EXPERT WITNESS REPORT

10 Sample Street, Essendon VIC 3040

Tribunal: Victorian Civil and Administrative Tribunal (Building and Property List)

File number: BPXXXX/2024

Figure 4: Side A, north boundary, measured elevation and comparison against sheet S9 Rev A.

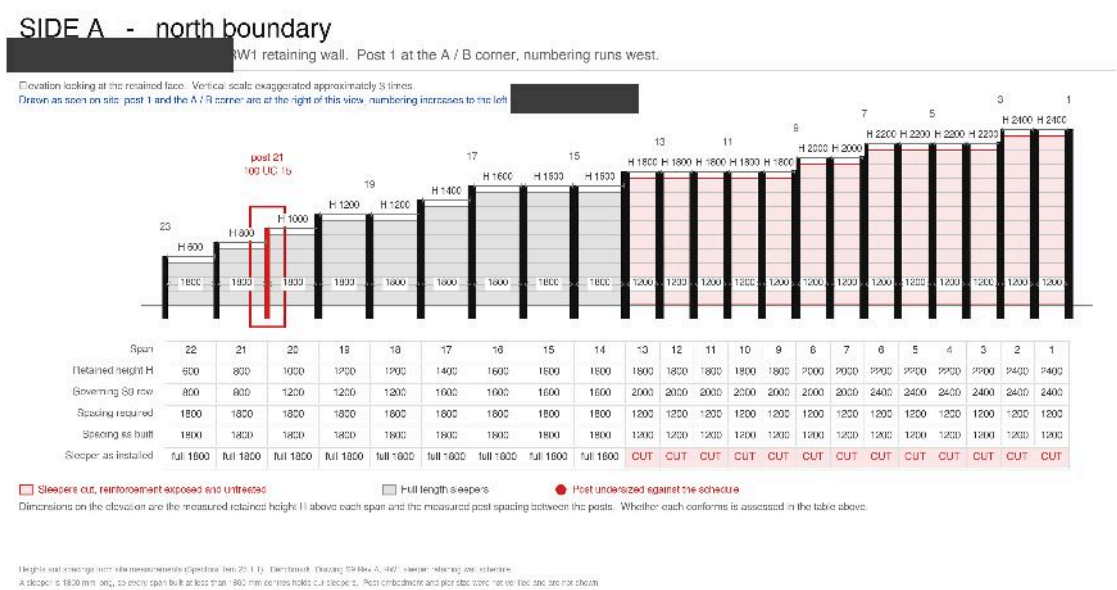
Elevation of the Side A run drawn to scale from the measured retained heights and post spacings, with the comparison against sheet S9 Rev A beneath. Drawn as seen on site, with post 1 and the A / B corner at the right. Vertical scale exaggerated approximately three times.

Appendix A1: Structural Engineering Drawings, sheet S9 Rev A, RW1 sleeper retaining wall schedule, Structural Engineering Firm job 21-60, Rev A issued for construction 30 July 2021 (highlighted).

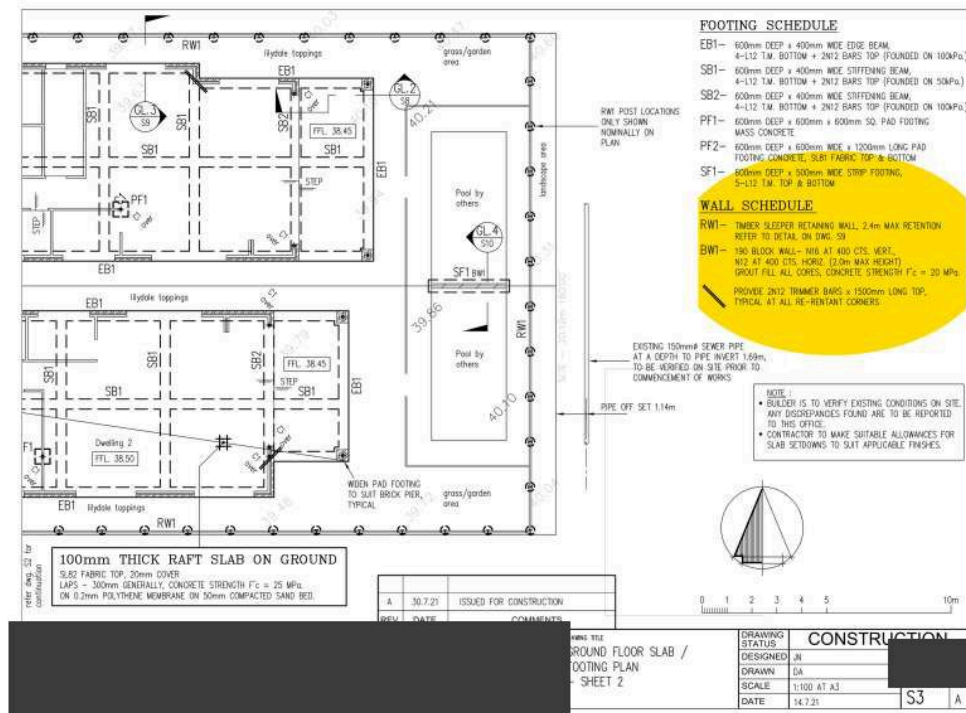
- Structural Engineering Drawings, sheet S9 Rev A, RW1 sleeper retaining wall schedule, Structural Engineering Firm job XX-XX, Rev A issued for construction 30 July 2021: "WALER: 200 x 100 F5 T/PINE (H3 TREATED)" (Appendix A1)
- Structural Engineering Drawings, sheet S3 Rev A, wall schedule: "RW1 - TIMBER SLEEPER RETAINING WALL, 2.4m MAX RETENTION. REFER TO DETAIL ON DWG. S9" (Appendix A2)
- Structural Engineering Computations, page 30, RW1 (2400) sleeper design, Structural Engineering Firm, 28 July 2021: "100mm x 200mm F5 Treated* (Weak) (Single layer sleepers)" (Appendix A3)
- Building Act 1993 (Vic), s 16(1)
- National Construction Code 2022, Volume Two, clause H1D3(2)

- **Design is timber.** S3 defines RW1 as timber; S9 specifies 200 x 100 F5 treated pine; all six computation runs check timber.
- **No concrete design.** None in the 41 pages of computations.
- **Certificate.** The 2 August 2021 certificate covers the timber design only.
- **Result.** Not built to the approved design, and nothing certifies what was built.
- **Instructed.** The Respondents say concrete was accepted provided design and spacing were unchanged. A2 shows the spacing was not.
- **The surveyor's records.** The Relevant Building Surveyor recorded an approved inspection of the rear retaining wall footings on 1 November 2023 and attended again on 7 May 2024. Those records do not certify the sleeper material and no design for a concrete sleeper wall was provided to the surveyor so far as the documents show, but they are matters the Tribunal should weigh.

Structural engineer to assess the walls as built against AS 4678 and the computations' assumptions, then certify or specify rectification. Must cover whether the concrete sleeper is at least equivalent in bending to the 200 x 100 F5 pine the spacings came from, and whether the piers remain adequate.

Appendix A9: Structural Engineering Drawings, sheet S2 Rev A, ground floor slab and footing plan sheet 1, western end of the Side C run (highlighted).

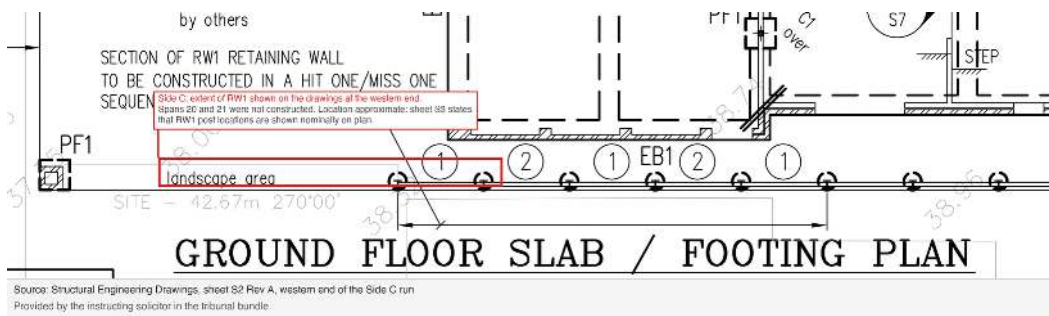
- Structural Engineering Drawings, sheet S2 Rev A, ground floor slab and footing plan sheet 1, western end of the Side C run (Appendix A9)
- Building Act 1993 (Vic), s 16(1)

If the agreement described to me is produced, the omission is an agreed variation rather than incomplete work, and this item falls away as a defect. Whether any adjustment to the contract price should have followed is a contractual question for the parties and their lawyers, not a matter for me.

First, provide a copy of the agreement between the owner and the contractor not to build the lower spans, and any contract or payment record showing whether the two unbuilt spans were included in, or deducted from, the contract price. If the agreement is established, no rectification arises.

If no agreement can be produced, refer to the engineer. If the spans are required, build them to the governing schedule row including piers, posts, sleepers and drainage. If they are not required, obtain an amended drawing recording the variation.
